DEPARTMENT OF STATE GROWTH

JUNE 2020

HOBART CITY DEAL SOUTHERN PROJECTS SUB-PROJECT 2: MACQUARIE STREET AND DAVEY STREET BUS PRIORITY
CONCEPT STAGE - ROAD SAFETY AUDIT

Figure C.2 Worn Line Marking - Macquarie Street looking at right turn from Southern Outlet

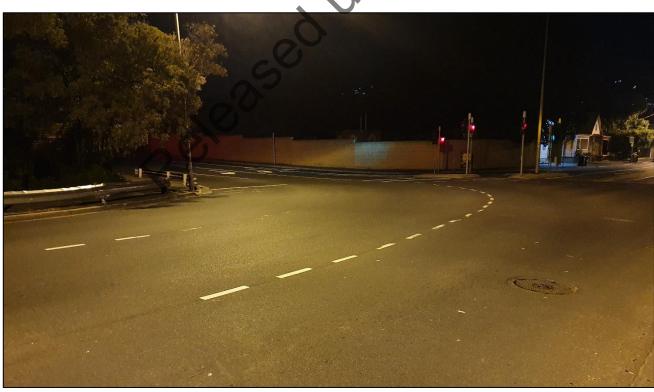
2.2.	The line marking between the two right most lanes on the turn from the Southern Outlet to Macquarie Street has been worn. This may result in side swipe collisions due to the lack of lane definition.	It is recommended that the line marking be reinstated with long lasting thermoplastic line marking.		96	To Note		Agreed, note in concept design report / costing design advice.

Figure C.5 Street Light

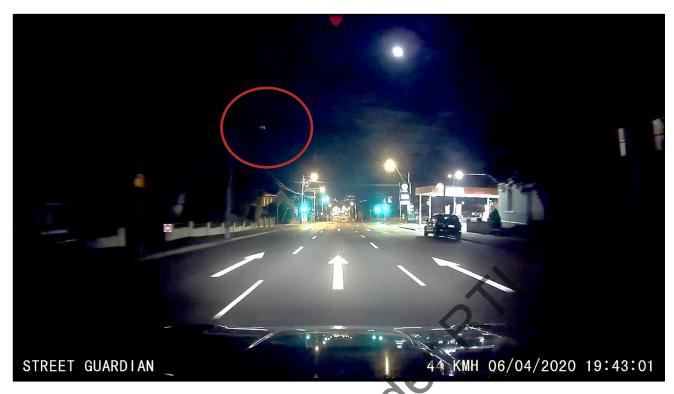
2.4.	There is a streetlight luminaire which is not functioning just south of Ispahan Avenue	It is recommended that the streetlight luminaire be replaced.	-	-	To Note		Noted. To be resolved in future stages of design.

Figure C.6 Tree obscuring streetlight

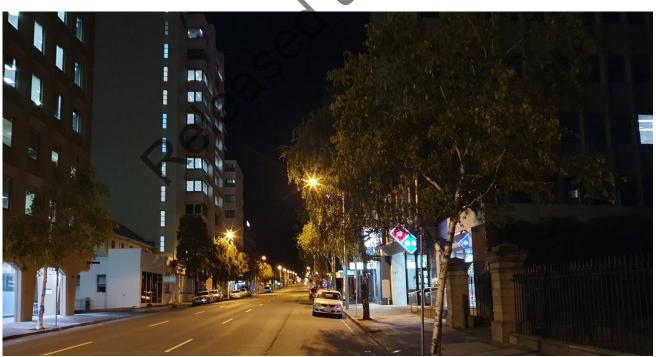
2.5.	Trees obscure the street lighting between Harrington Street and Murray Street.	Consider truming or removing trees so that the street lighting is less obstructed.	-	-	To Note		Noted. To be resolved in future stages of design.

Figure C.19 Obscured Signs

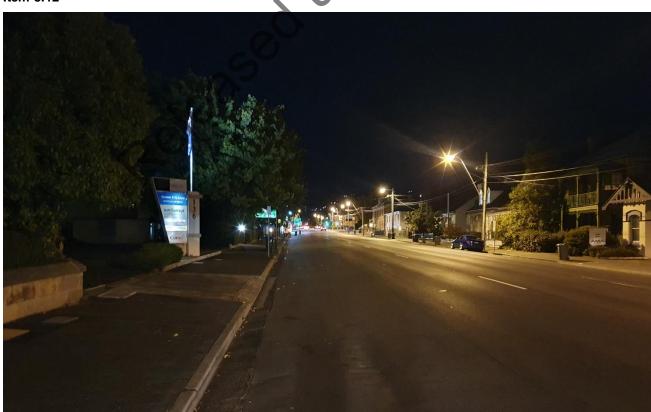
3.12.	The University of Tasmania advanced direction sign north of Antil Street is partially obscured by vegetation. This may result in sudden lane changes from drivers, resulting in a collision.	Vegetation to be trimmed so that the sign is less obstructed.	Occasional	Limited	Low		Noted. To be resolved in future stages of design.

Figure C.21 Obscured signs

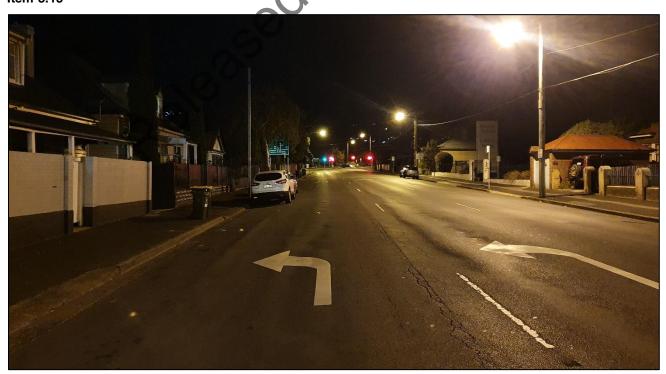
3.15.	The advanced direction sign on the approach to the Southern Outlet is partially obscured by vegetation. This may result in sudden lane changes from drivers, resulting in a collision.	Vegetation to be trimmed so that the sign is less obstructed.	Occasional	Limited	Low		Noted. To be resolved in future stages of design.
